Subject: Re: follow up drawings regarding Petition No. 2013-0250

From: Jonathan Ochshorn
Date: Thursday, October 3, 2013 11:13 AM
To: Brian Tollisen
Cc: Charles Bliss, Mike Niechwiadowicz, Gary Norbert Wilhelm, Ed Girzone
Subject: Re: follow up drawings regarding Petition No. 2013-0250

From: Ken Dias
Date: Wednesday, July 24, 2013 8:40 AM
To: Jonathan Ochshorn
Cc: Maughan, Kevin
Subject: RE: Use of Tyco Model WS 5.6 K-Factor Window Sprinklers

Subject: Use of Tyco Model WS 5.6 K-Factor Window Sprinklers

Figure 3B-3 — WINDOWS WITH HORIZONTAL MULLIONS

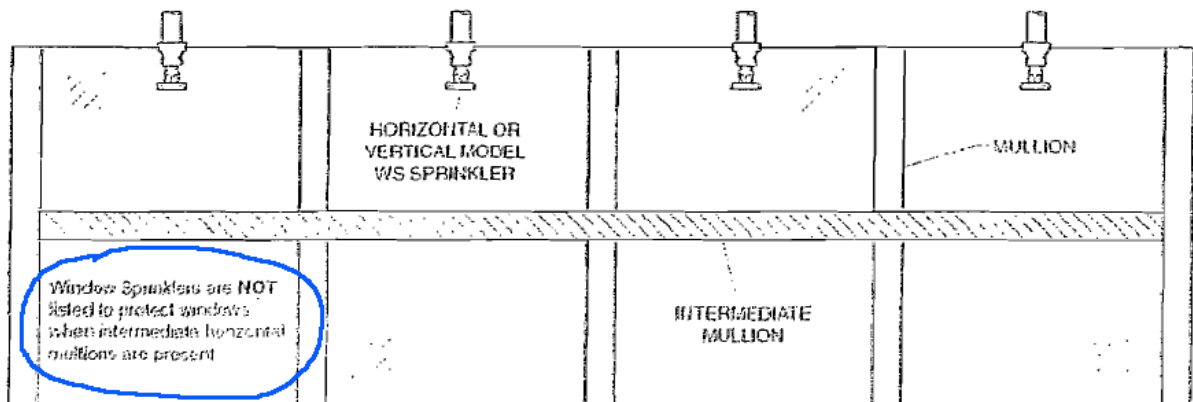
Figure 3B in the **TYCO** product description included in the City of Ithaca's submission reinforces the same prohibition: "Window Sprinklers are **NOT** listed to protect windows when intermediate horizontal mullions are present."

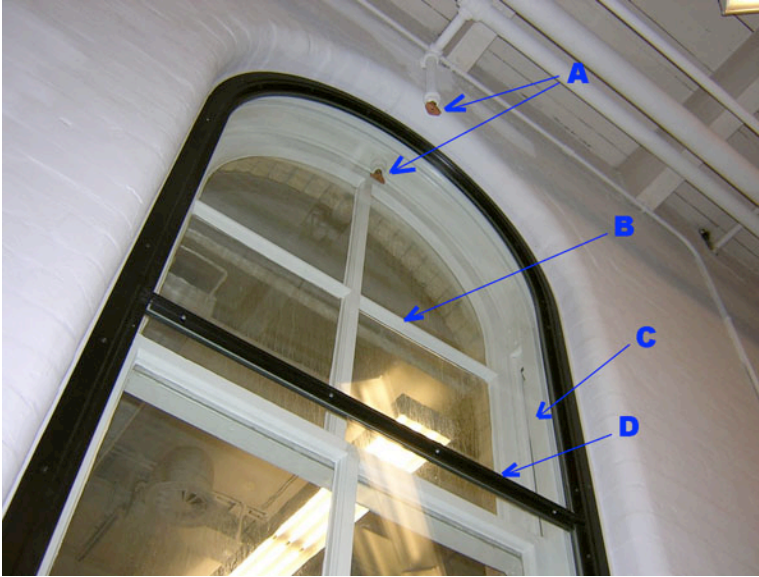
There are four items marked on the photo, and I wish to get your evaluation or comments on each of them: specifically, based on the information I have provided, do they conform to the requirements of ESR-2397 or NER-516.

Item A shows the two vertical sidewall sprinklers. One of the two sprinklers is sandwiched between the new fire-rated glazing (in the black metal frame) and the existing window. This "inside" sprinkler is *less than 4 inches from the face of the fire-rated glazing*.

Item B shows the existing wood-framed window in this installation. The "inside" sprinkler described in Item A is *sandwiched between the existing window and the new fire-rated glazing*.

Item C shows the wood (combustible) frame of the existing window, which is *less than 2 inches from the fire-rated glazing*.

Item D shows a *horizontal mullion* (or muntin) that projects out from the face of the fire-rated glazing more than 5/8 inch.

It appears that the intended use of the WS sprinklers per your provided photo is to provide a fire rated "equivalency" to the newer pane of glass (in black frame) located adjacent (in front) of the original window. I will therefore first address my comments with regard to this.

You have stated that the inside vertical WS sprinkler is less than 4 inches from the inside face of glass. The UL Listing requires a minimum of 4" from the face of glass. We have not performed testing at distances less than 4 inches to my knowledge and therefore cannot speculate on the impact of the distribution of water onto the glazing. **There appears to be a horizontal mullion running across this new pane of glass. Horizontal mullions are not allowed in accordance with the UL Specific Application Listing.**

You have stated that the wood framing from the original window is less than 2" from the new glazing. The UL Listing requires that all combustible material must be a minimum 2" from the face of glazing.

With regard to the WS sprinkler on the other side (outside) of the newer glazing, I have the following comment. **You have stated that there is a horizontal mullion projecting more than 5/8" from the glazing. It is likely that this horizontal mullion would impede the smooth continuous flow of water down the glazing and create unacceptable dry spots. Again, horizontal mullions are not allowed in accordance with the UL Specific Application Listing.**

Lastly, this installation is quite unique in nature as it encompasses a "new" piece of glazing located off of an existing window, resulting in an "enclosed" area between two pieces of glazing where one of the two WS sprinklers is located within. This arrangement was not considered in the UL testing nor is it addressed within the evaluation service reports. It should be understood that the intent of the WS Window Sprinkler is to realize activation in a timely enough manner to protect the associated glazing. **The existence of two panes of glass on either side of the one WS sprinkler will result in the prevention of hot gasses to that sprinkler until such time that the original pane may rupture. Consideration should be given to what will happen to the rupturing pieces or sections of glass. Could large pieces somehow be propped up against the newer pane, causing an obstruction to the smooth flow of water down this pane?**

In conclusion, this installation does not appear to be in compliance with the UL Listing per Tyco data sheet TFP620, ESR-2397 or NER-516
